Public comments on Winter Bd. Meeting of U.S. NWTRB at Las Vegas Jan 28, 2009 ---- from Fawn Shillinglaw, 1952 Palisades Dr., Appleton WI, 54915 – Feb 25, 2009 (from Transcript Pages)

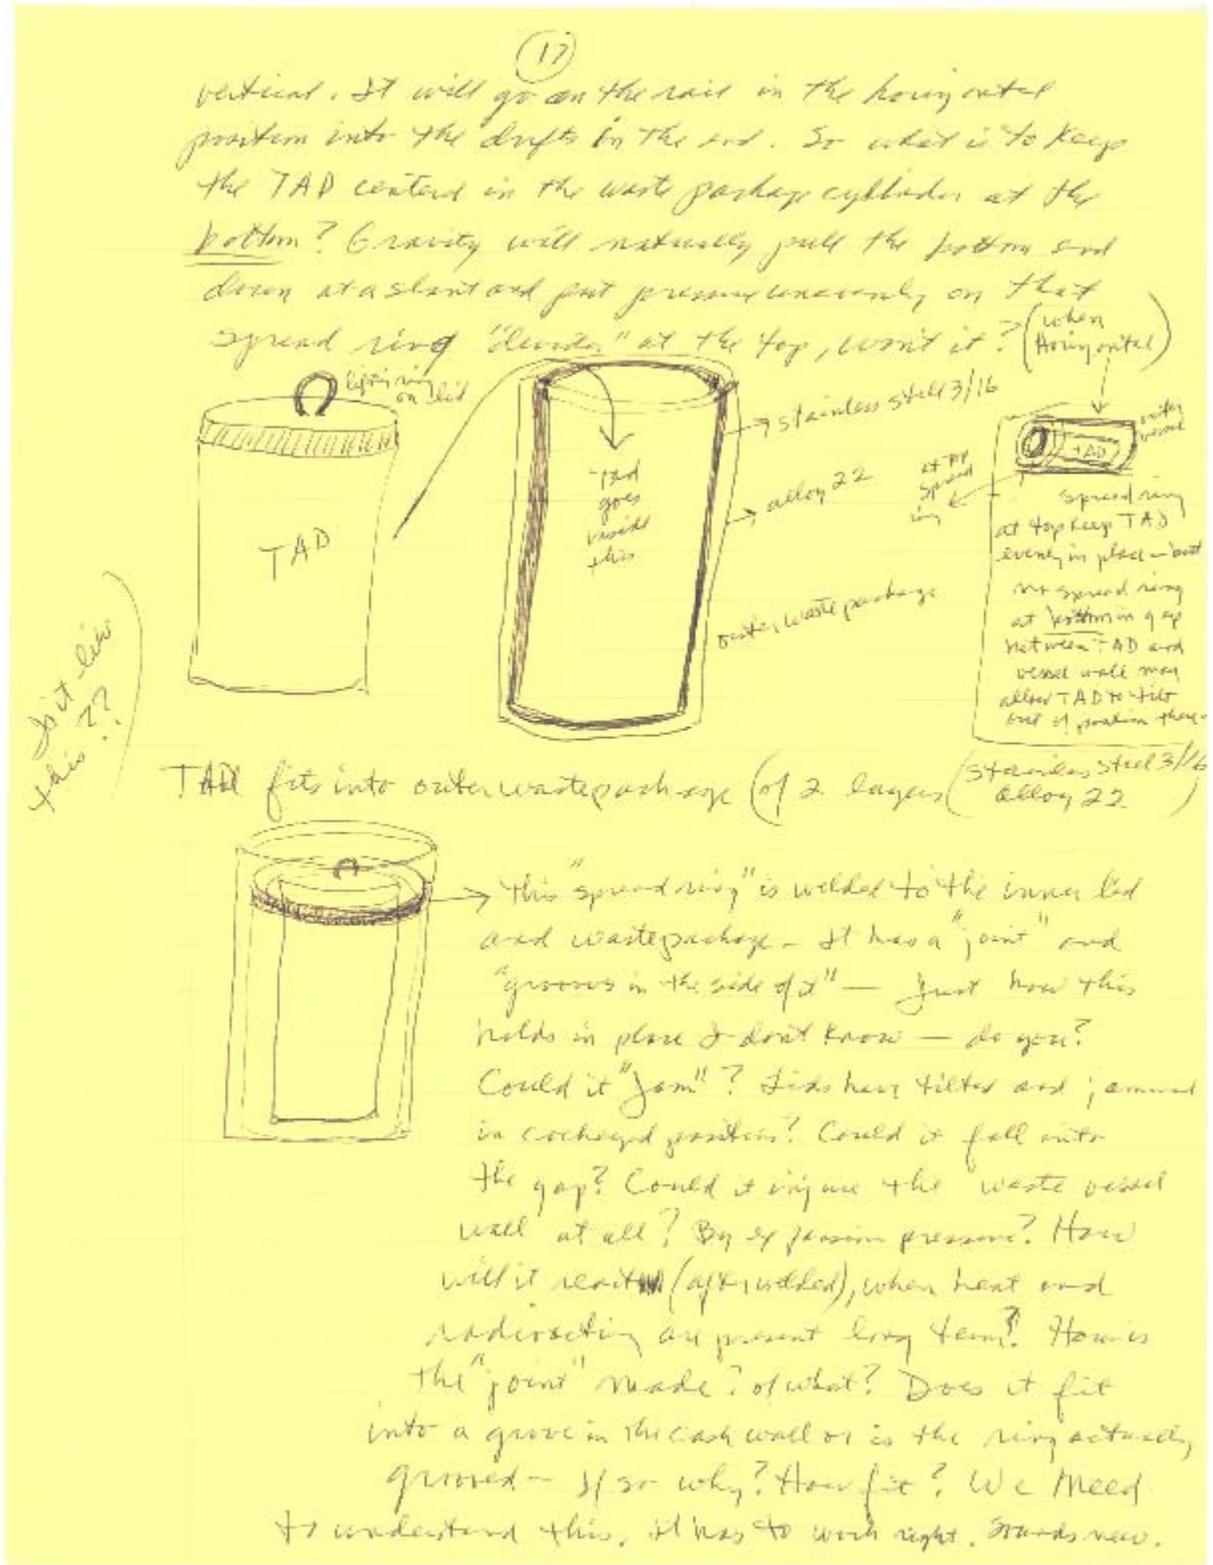
package cylinder at the bottom? Gravity will naturally pull the bottom end down at a slant and put pressure unevenly on that spread ring "divider" at the top, won't it? (See the following diagrams)

(middle side of upper page) (when horizontal) outer vessel spread ring at top keep TAD evenly in place – but not spread ring at bottom in gap between TAD and vessel wall may allow TAD to tilt out of position there. (insert in above diagram) TAD fits into outer waste package (of 2 layers (stainless steel 3/16 alloy 22) This ‘spread ring’ is welded to the inner lid and waste package – it has a “joint” and “grooves in the side of it” --- just how this holds in place I don’t know --- do you? Could it “jam”? Lids have tilted and jammed in cockeyed positions? Could it fall into the gap? Could it injure the waste vessel wall at all? By expansion pressure? How will it react (after welded), when heat and radioactivity are present long term? How is the ‘joint’ made? Of what? Does it fit into a groove in the cask wall or is the ring actually grooved – if so why? How fit? We need to understand this. It has to work right. Sounds new.
